# DRESDEN NUCLEAR POWER STATION

UNIT 3

AMENDMENT 6

Commonwealth Edison Company respectfully submits herewith Amendment No. 6 to the Plant Design and Analysis Report for Unit 3 at the Dresden Nuclear Power Station.

Figure I. Core Spray System

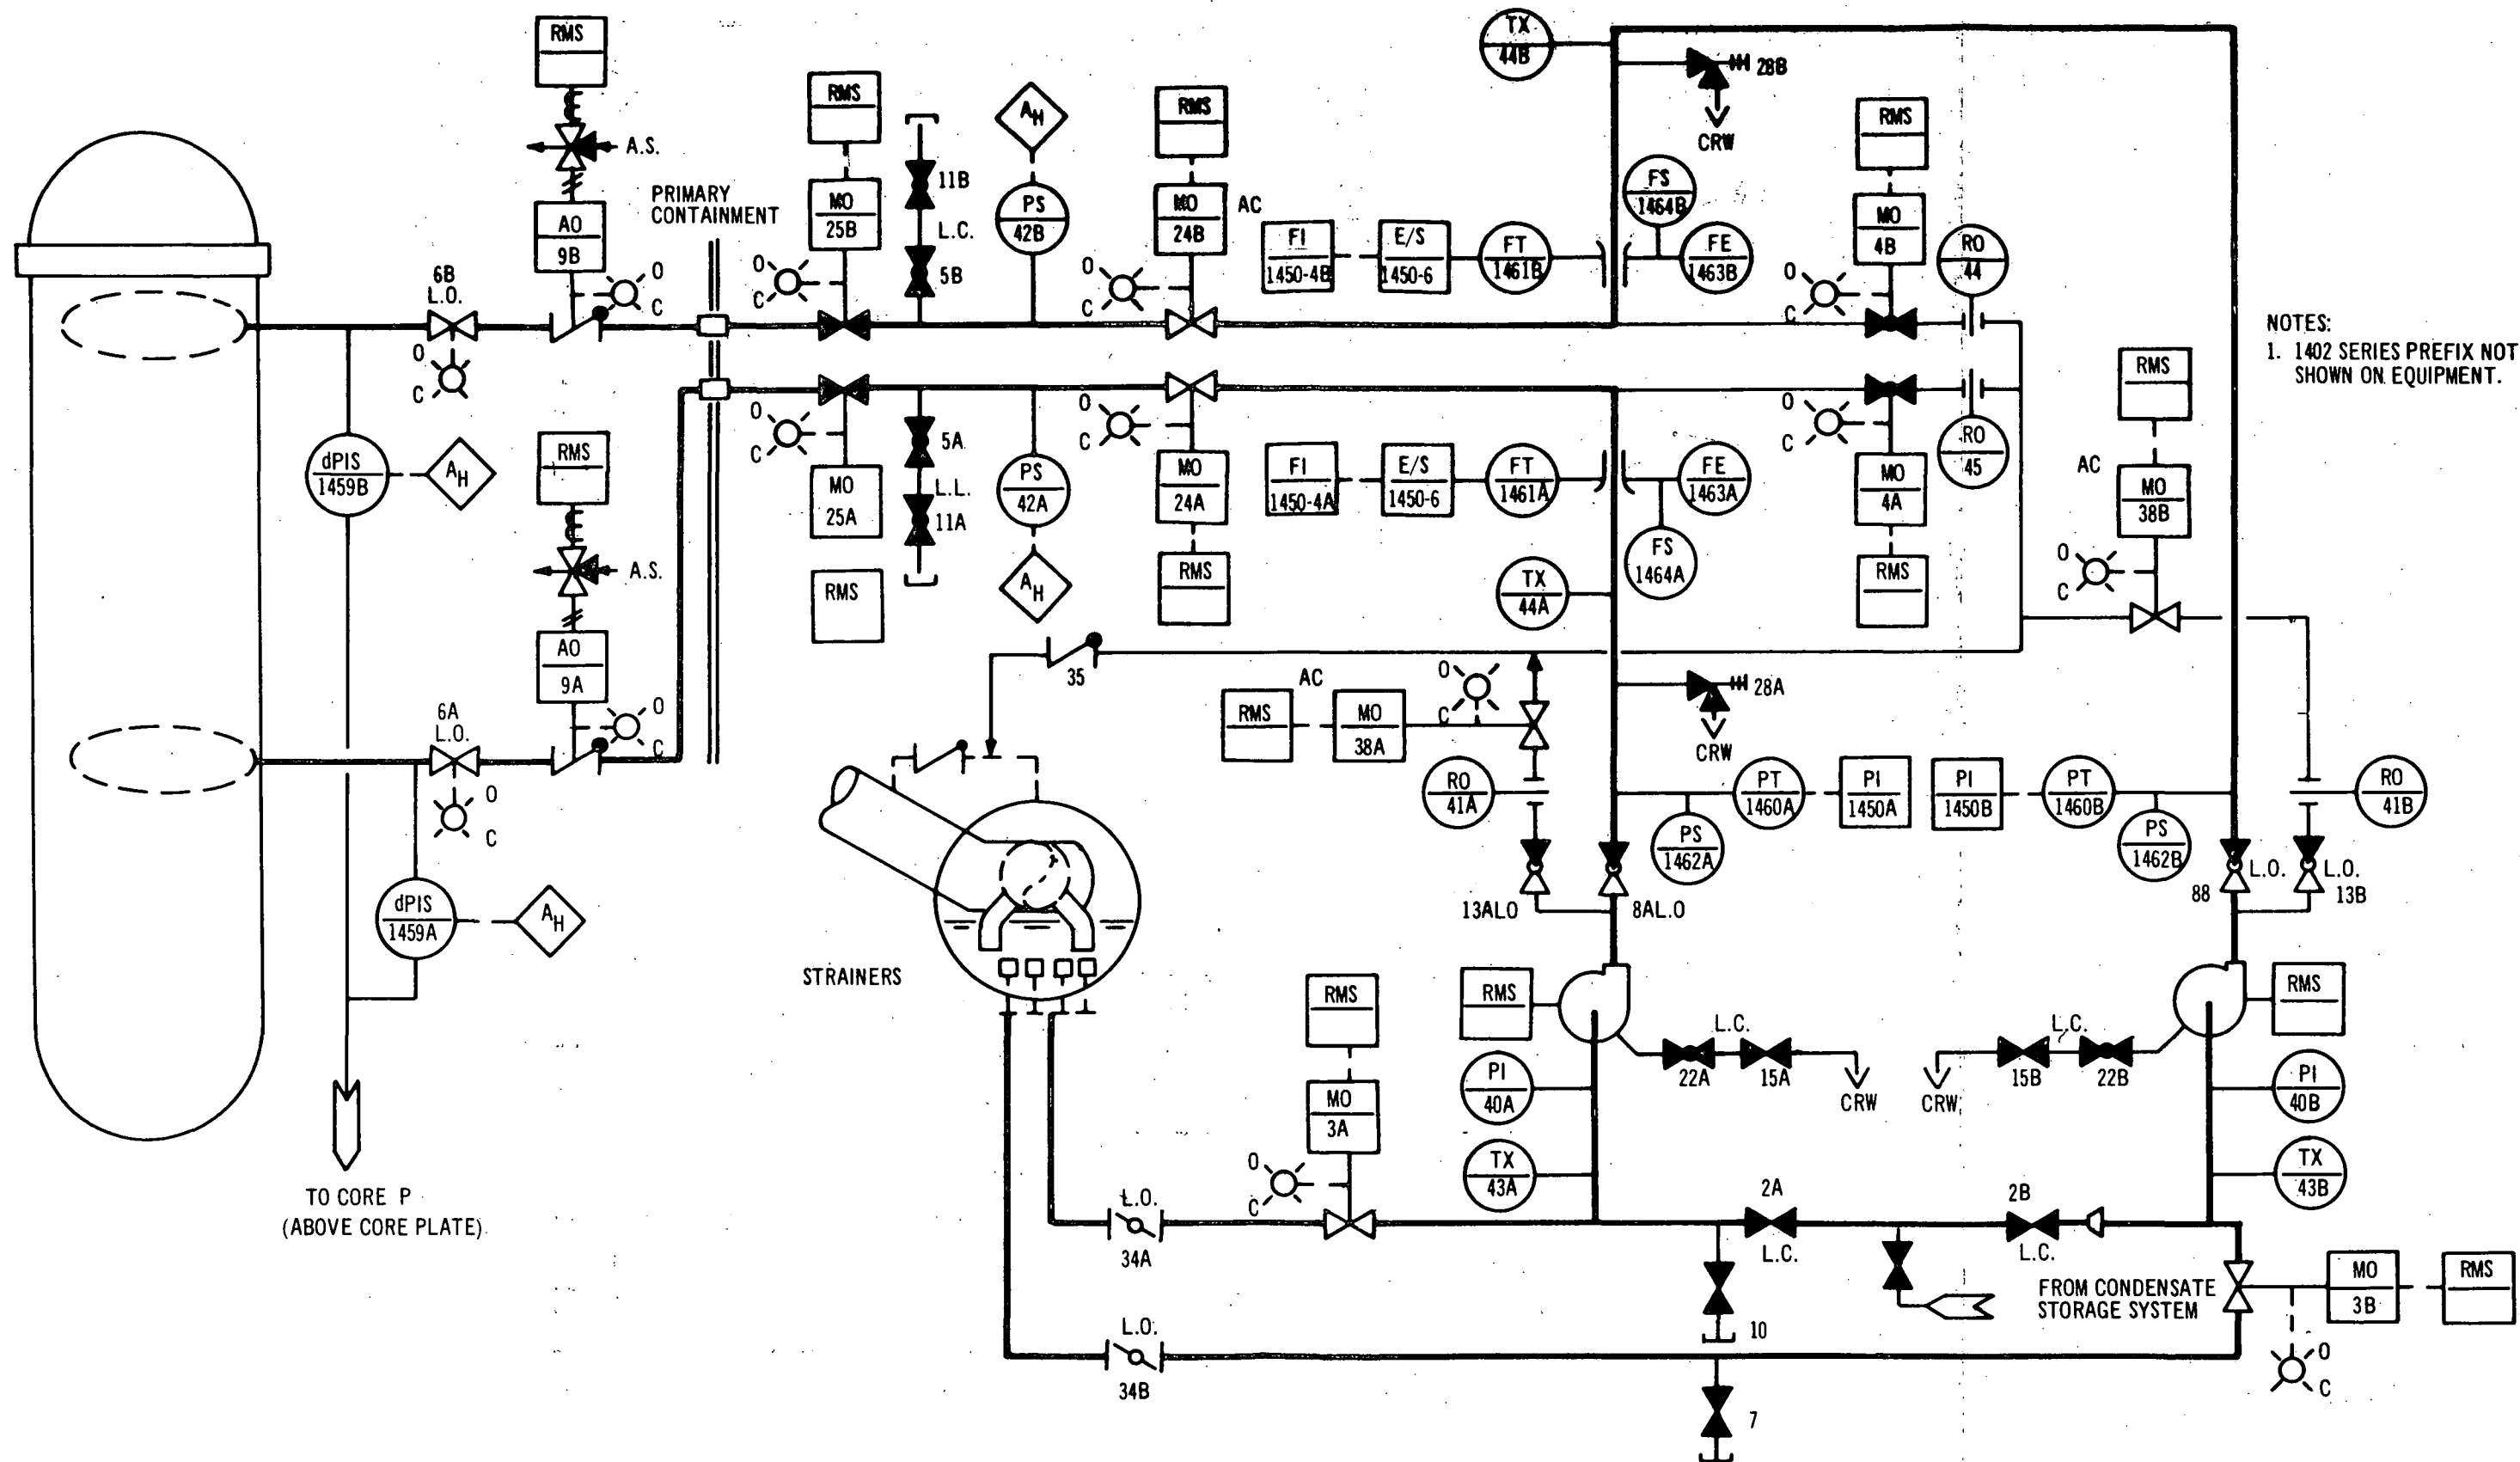
The core spray systems to be provided for Dresden Unit-3 will be identical in design concept and performance to the core spray systems, incorporated in the Quad-Cities Units 1 and 2. Two independent full capacity core spray systems are provided to each reactor. Each system consists of a pump, piping, valves, instrumentation and a spray ring header. Each of the two core spray systems is designed to pump water directly from the suppression pool into the reactor vessel. The piping and instrument diagram for the systems is shown in Figure I. The capacity of each of these systems is sufficient to provide core cooling and prevent fuel clad melting under the loss of coolant conditions which might result from large pipe breaks and reactor vessel depressurization.

The design flow capacity of the pump in each core spray system is approximately 4700 gpm at a total delivered pump head of 230 psig; the power required for each pump is approximately 860 HP. The water source for the pump suction is the 800,000 gallon suppression pool. The other core spray system equipment specifications are shown in Table II.

Each core spray system supplies water to a spray ring header located inside the core shroud of the reactor vessel directly above the core. Water is sprayed directly onto the top of fuel assemblies in a pre-established pattern through approximately 130 spray nozzles mounted on the spray ring header. The required flow rate was based upon prototype testing of a full scale fuel assembly under actual power conditions, using the actual core spray distribution. To verify that the test conditions did indeed simulate the most limiting situation, the test fuel rods were allowed to overheat (1250°F) prior to core spray activation. In addition, the channel boxes were allowed to stay at high temperature. Each core spray system has been sized to provide at least the minimum required flow rate to each fuel assembly in the core. Flow distribution in the upper plenum as well as leakage flow available to fuel rods were accounted for in determining the core spray flow requirements.

The piping of each core spray system is fabricated of carbon steel from the suppression chamber to the outer isolation valve. Safety valves are utilized for pressure protection of this section of the system. From the outer isolation valve into the reactor, the system is fabricated of stainless steel and designed for service at 1,250 psig and 575°F. The spray ring header and nozzles are fabricated from 304 stainless steel to ASME, Section III Code. The core structure supporting the spray ring header is also fabricated of 304 stainless steel material. The vessel nozzle entry material is Ni-Cr-Mo forging fabricated to ASME SA336 and modified by ASME Code Case 1332.

The piping of the core spray system inside the reactor vessel connects each spray ring header to a reactor pressure vessel penetration. This piping is designed and located to meet the necessary thermal expansion requirements and to accommodate vessel movement from postulated accidents. The pipe runs of each system are physically separated, and are located to take maximum advantage of the protection afforded by structural beams and columns. Drywell penetrations for the core spray pipes are located to achieve minimum length pipe runs within the drywell and to provide maximum circumferential distance between main steam and feedwater lines.

The core spray pumps and motors are located in the lowest level of the reactor building. The maximum ambient environment under accident condition to be 150°F at a relative humidity of 100%. Each system is physically separated by locating pumps in different corners of the reactor building. Pump suction is provided from the pressure suppression pool by a common ring header which has four stainless steel screened suction

lines. These screens are positioned above the bottom of the suppression pool but are well below the pool surface to minimize the risk of plugging the screens with debris. Sufficient system flow area is available (with one completely plugged suction screen) to meet the combined requirements for the use of the core spray systems, the LPCI system and the High Pressure Coolant Injection System. Screen size (1/8" openings) has been selected to eliminate entry of particles capable of plugging the smallest spray nozzles.

A low-water level signal starts the core spray pump in each system and provides one-of-two permissive signals to the startup valves MO-25-A and MO-25-B (see Figure I). These valves actually open only after reactor pressure decays below pump discharge pressure, at which time the second permissive signal occurs to open the startup valves. A low pressure indication from either core spray system provides the necessary second permissive signal to open both startup valves. In the event a core spray system pump fails to deliver flow within 10 seconds after the valves start to open, the pump in the other full capacity core spray system will start automatically.
